ROCKY FLATS SITE

REGULATORY CONTACT RECORD 2015-04

Purpose: Mound Site Plume Treatment System (MSPTS) Reconfiguration Conceptual Approach

FIGURE 1

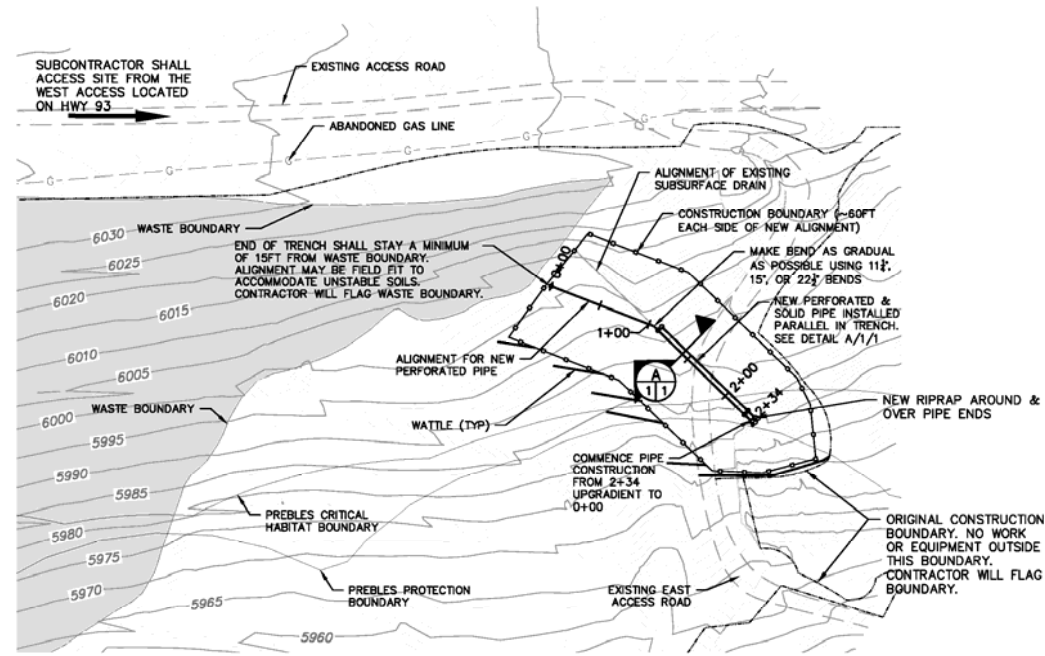
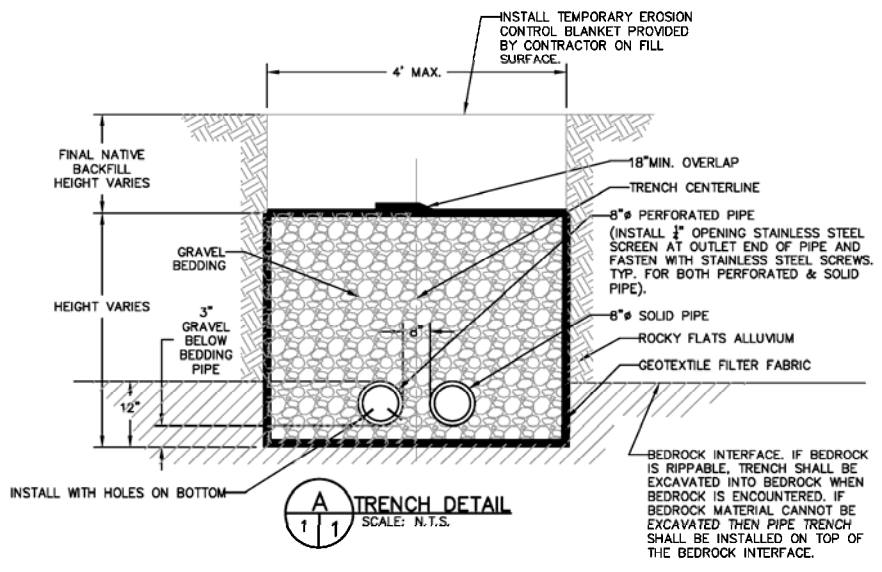
Based on the information above, the ESSD needs to be repaired and upgraded so that it properly functions and is less likely to clog. This action should be completed before the spring of 2017, when groundwater levels are again anticipated to rise and additional hillside movement is more likely. The repair and upgrade include excavating and replacing approximately 134 feet of the 234 feet of existing clogged rock drain and replacing the westernmost 100 feet of the original ESSD with a segment that is slightly south of the current drain alignment (see Figure 1). This realignment will avoid digging in the steepest portion of the slope. The total length of the excavation will be approximately 234 feet, and it will range from a depth of approximately 15 feet at the upgradient end to zero feet where the drain daylights. An 8-inch perforated pipe, with cleanout risers appropriately located for observation and cleanout, will be contained within a gravel bed that will be wrapped in geotextile filter fabric as shown in Figure 1. The pipe and cleanouts will allow the continued maintenance of the drain and will therefore extend its operable lifetime. The trench that is excavated for this work will be entirely outside the waste footprint but inside the original OLF construction boundary. Some construction equipment may be placed on the OLF cover above the waste footprint to safely install the upgraded ESSD.

A portion of the repair and upgrade work to the ESSD will be performed in an already disturbed Preble's meadow jumping mouse critical habitat, within the OLF original construction boundary (see Figure 1). As required by the United States Fish and Wildlife Service (USFWS) Biological Opinion for the Preble's meadow jumping mouse at Rocky Flats, the USFWS will be a notified prior to start of construction.

Resolution: CDPHE reviewed the information regarding the proposed soil disturbance and excavation and after consultation with EPA, has approved this contact record. CDPHE has determined that the proposed activity will not compromise or impair the function of the remedy or result in an unacceptable release or exposure to residual subsurface contamination. CDPHE has also determined that the proposed project meets the rationale and objectives of IC 2 (IC 3 and IC 6 rationale and objectives have been addressed as stated above).
